From: Mark Valeriote To: Wade, Lowell Subject: Adfreeze Piles

Attachments: Adfreeze Pile.pdf

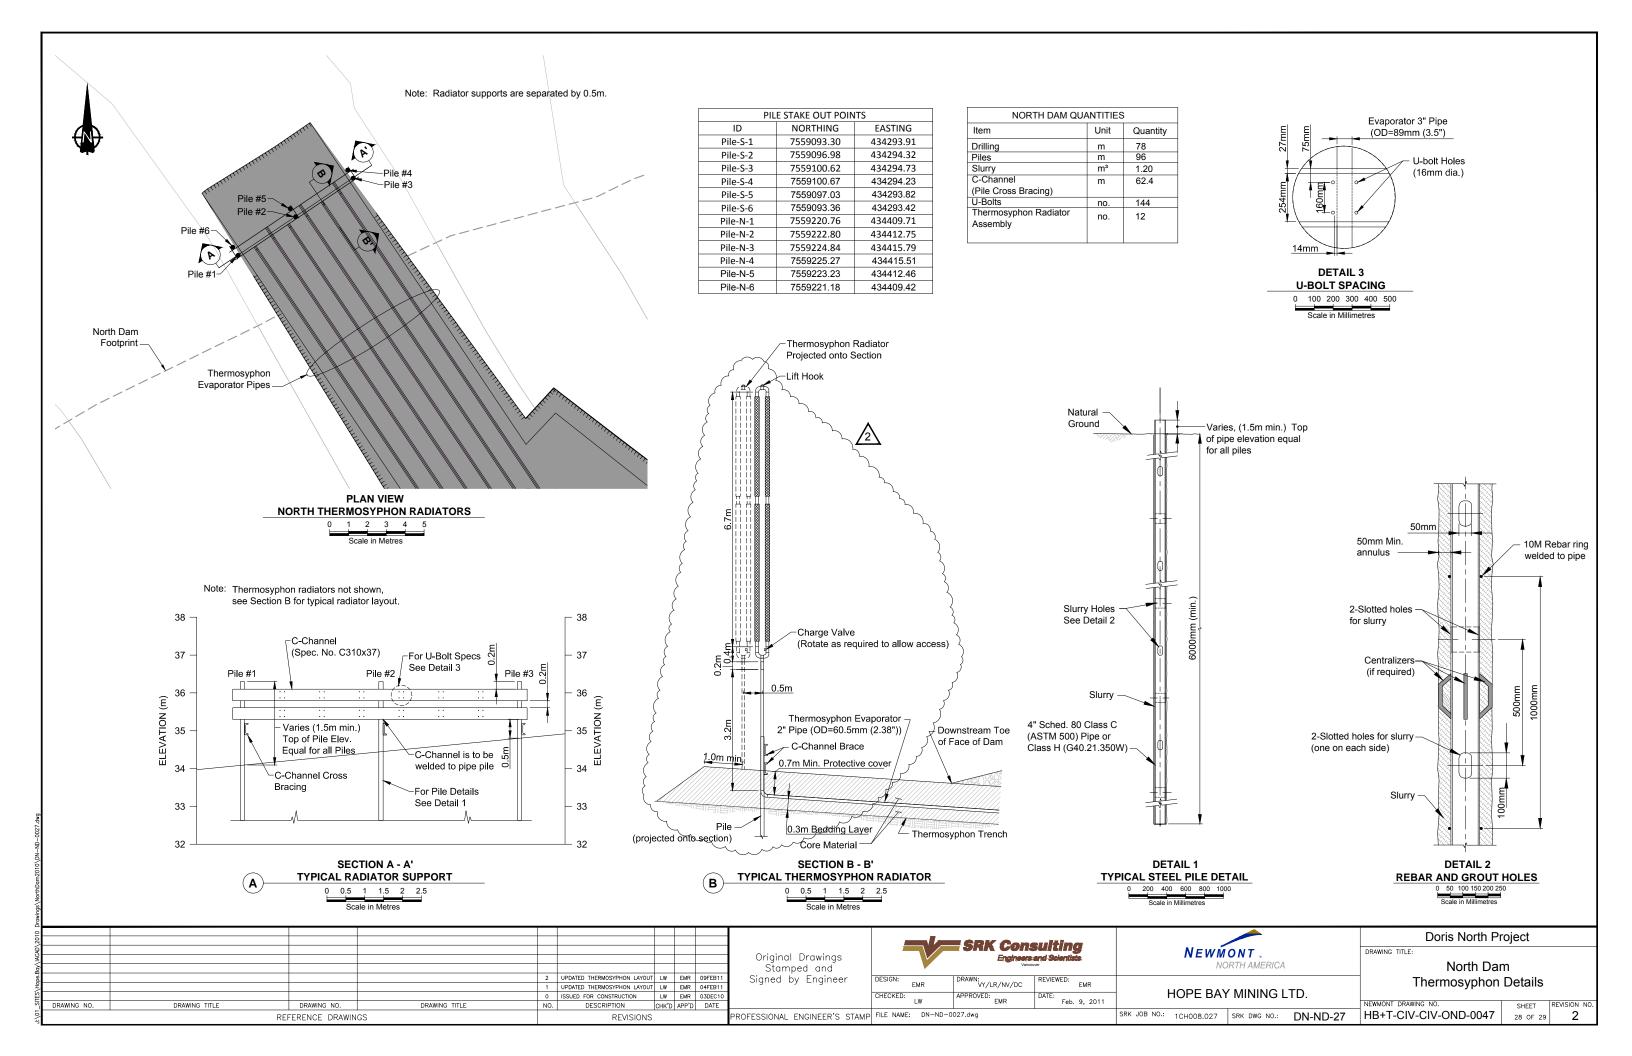
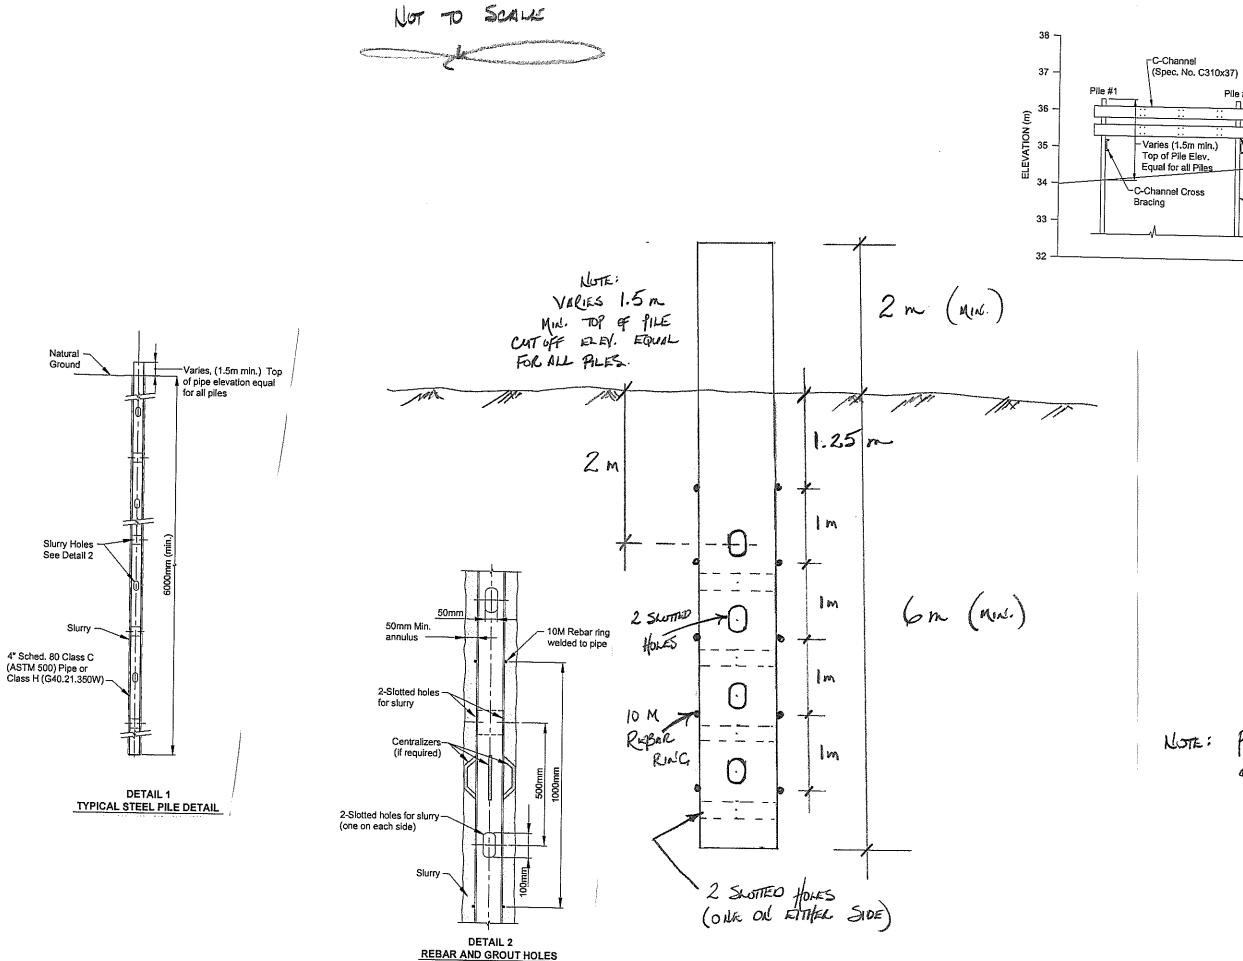
Yesterday afternoon we discussed a few details associated with the adfreeze piles. As I showed you there is no dimension on Drawing DN-ND-27 to define where the first 2 slotted holes should be placed. Once this is established the location where the 10M steel rings can also be determined. Please confirm that you suggested the first 2 slotted holes should be fabricated at 2 m below ground surface. I have attached a sketch (shop drawing) that illustrates my understanding of our discussion.

We also discussed the centralizers illustrated on Drawing DN-ND-27. You noted that you require a means to ensure the pile is not situated along the wall of the drilled hole. In addition, you noted that multiple centralizers are not required along the length of the pipe. I informed you that I would give the matter some thought and provide a suggested method to accomplish the intent.

The holes that McCaw North will drill wherein the pile will be installed will not be a gauge hole. In addition, we do not have material to fabric a spring type centralizer that will deform to the hole when installed. I propose to install a minimum of three (3) lugs on the pipe at different elevations. The lugs will be less than the 50 mm (min.) annulus dimension shown on the drawing to ensure the pile does not hang up in the hole. This will provide an annulus between the pipe and the wall of the hole that will be filled with slurry. If need be the pile can be temporarily placed at surface to support the pile.

Please review the attached sketch and let me know if I can go ahead and have the piles fabricated.
